REQUEST FOR INFORMATION

PROJECT NAME		RFI NUMBER	DATE OF REQUEST
Royal Theater		12	8/15/2025
PROJECT LOCATION		PROJECT ID	DRAWING ID
848 Guadalupe Street Guadalupe, CA		825	
RFI OVERVIEW		SECTION(S) REFERENCED	
CHANGE IN COST		CHANGE IN TIME	
NO CHANGE		NO CHANGE	
INCREASE IN COST	\$ -	INCREASE IN TIME	# of Days =
DECREASE IN COST	\$ -	DECREASE IN TIME	# of Days =

U1.0

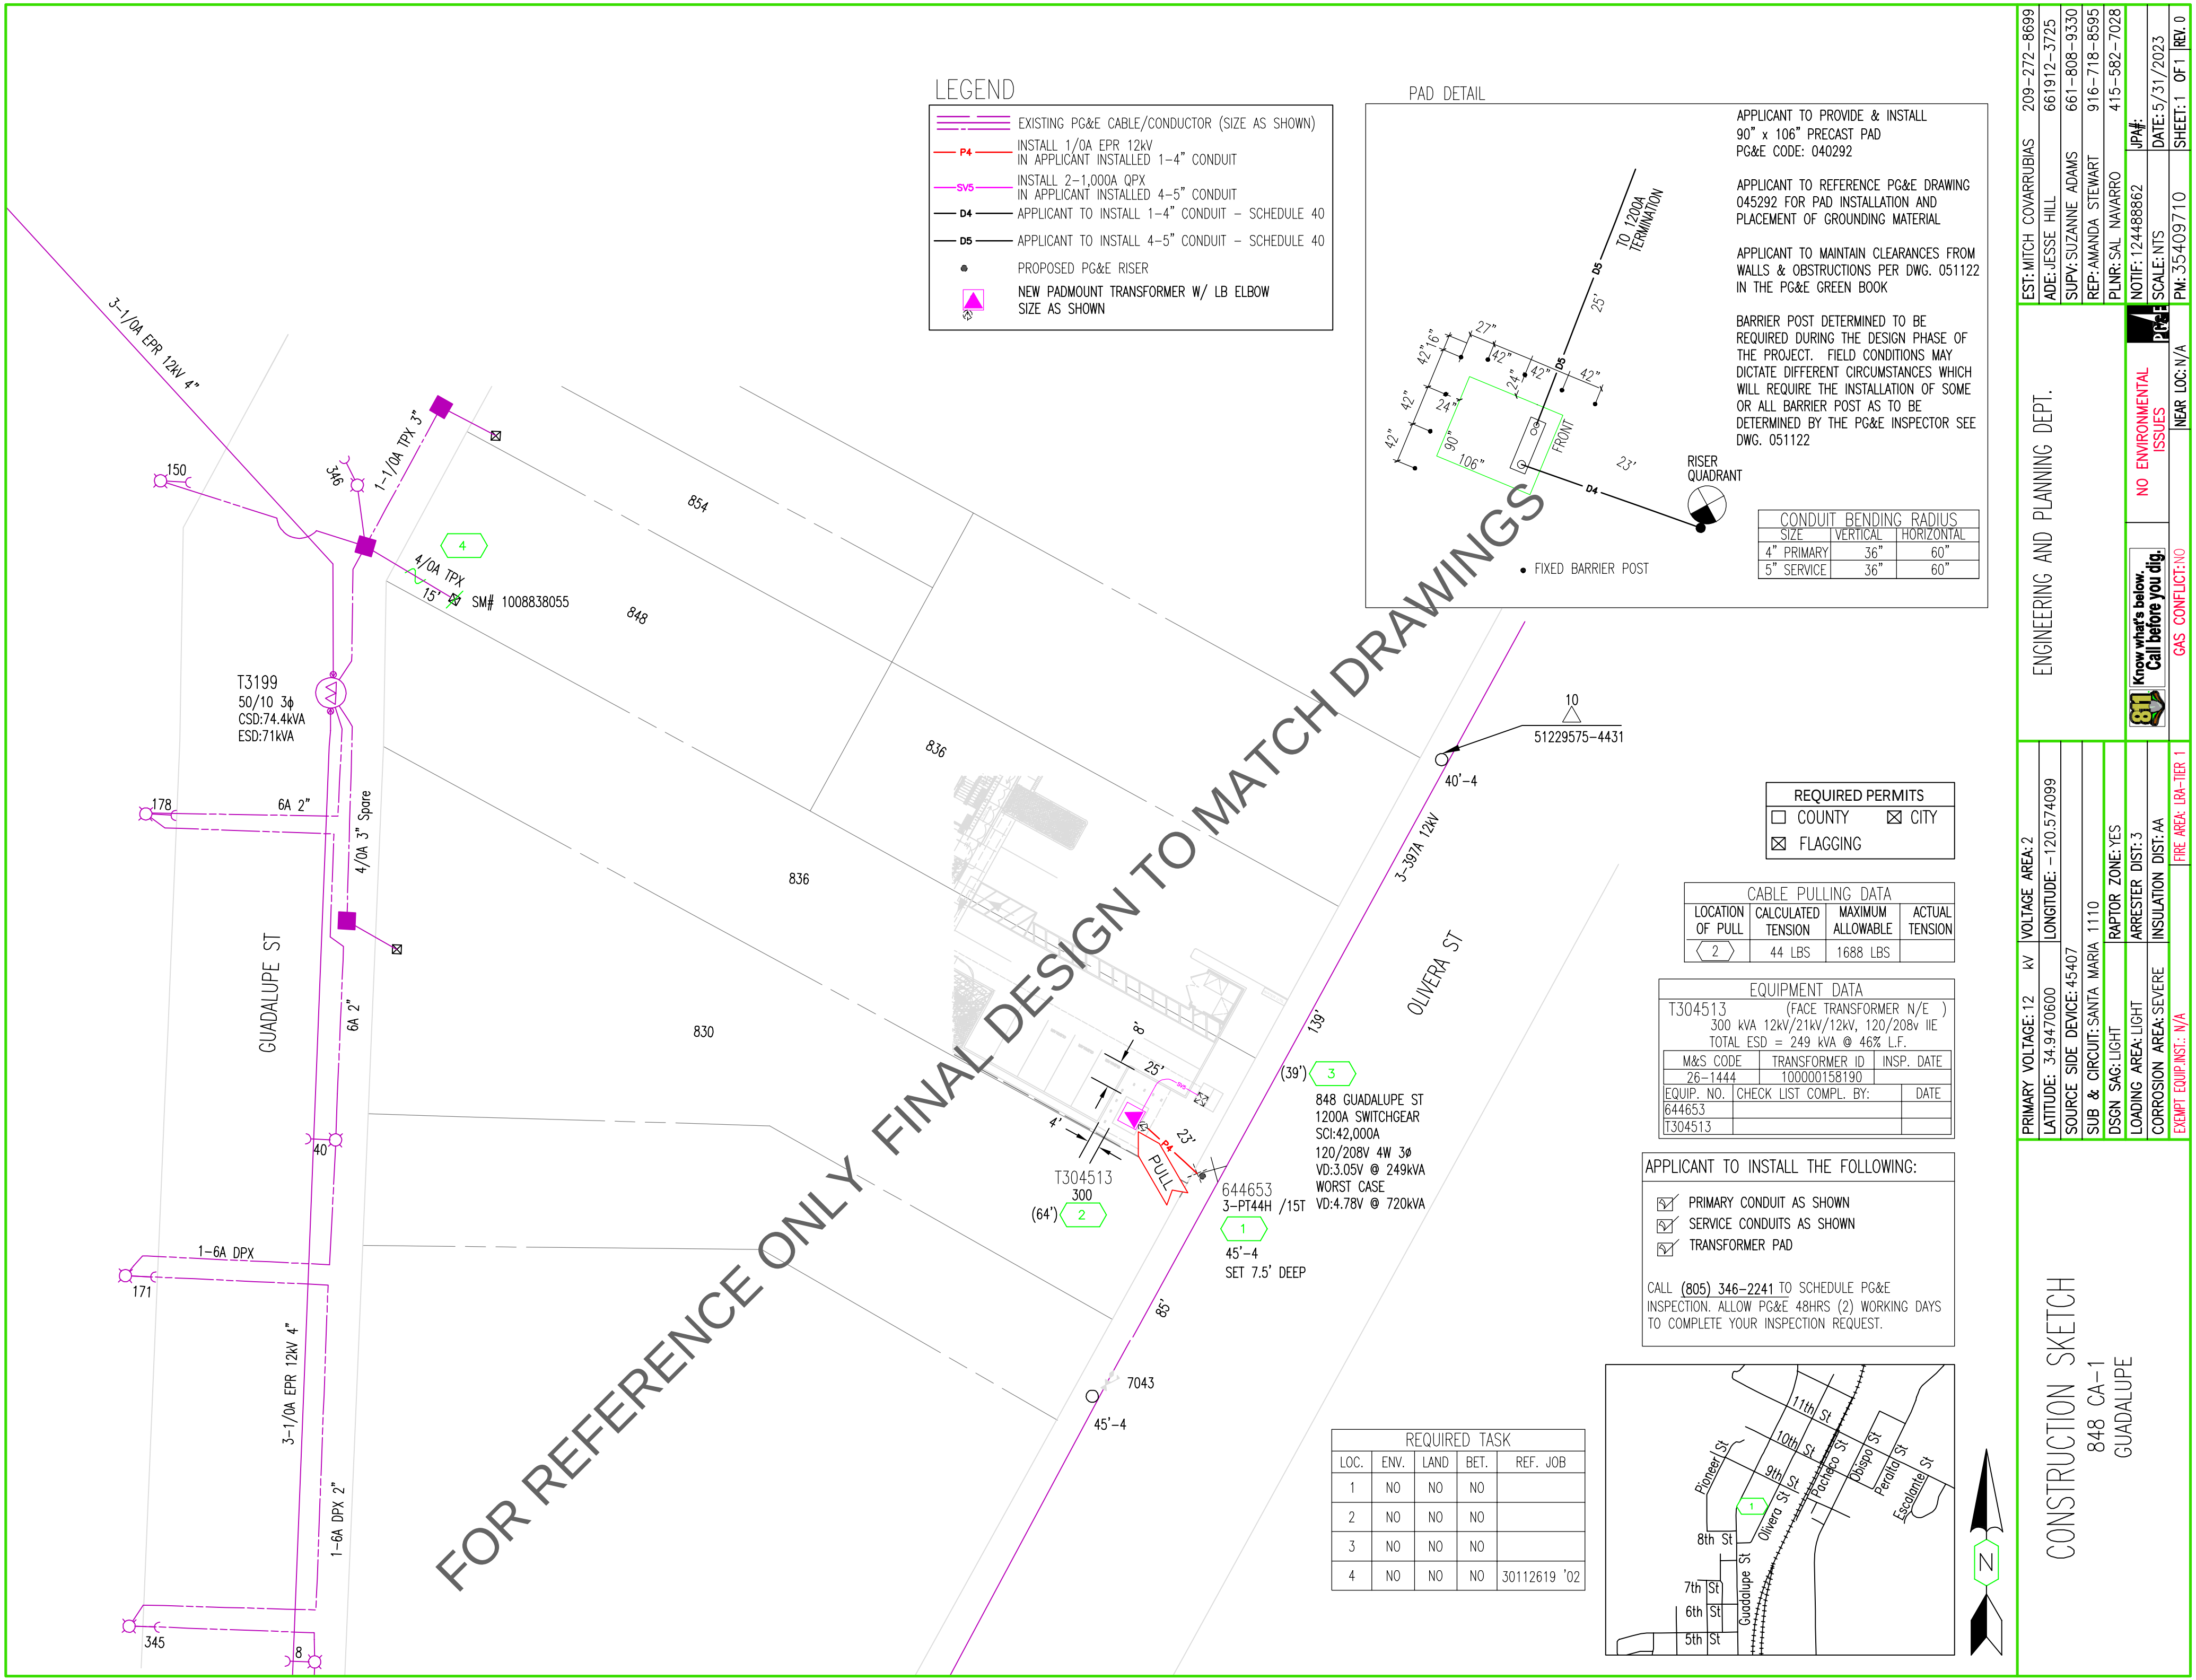
- 13. The entire wall needs to be assessed and areas repointed as necessary
- 14. See attached URM Testing Layout
- 15. No.
- 16. There is this requirement for the North wall as well. See sheet A3.10

URM TESTING NOTES:

Pursuant to code requirements and T&S structural plan notes stating that brick strength and pointing must be evaluated with regard to the requirements of 2022 CEBC Appendix Ch. A1 prior to construction, all existing URM walls must be tested by a qualified testing agency as noted below.

1. Observe all masonry walls and note locations where wall is not in good condition per CEBC Section A106.1 (e.g. where there is degraded mortar, degraded masonry units, or significant cracking).

2. In regions designated on the plan below, choose locations representative of the mortar conditions and test mortar joint shear values per ASTM C1531.

3. At each in-place shear test location, also:
 - 3a. Inspect collar joints, estimating the percentage of surfaces of the adjacent wythe that are covered with mortar.

- 3b. Test the splitting tensile strength of existing masonry per ASTM C496.
4. Where existing wall anchors are observed (during testing or during the future construction phase), document anchorage and report information to T&S Structural. Testing will be required per ASTM E488, following the requirements of CEBC Section A107.5, at locations and frequency designated by the engineer.
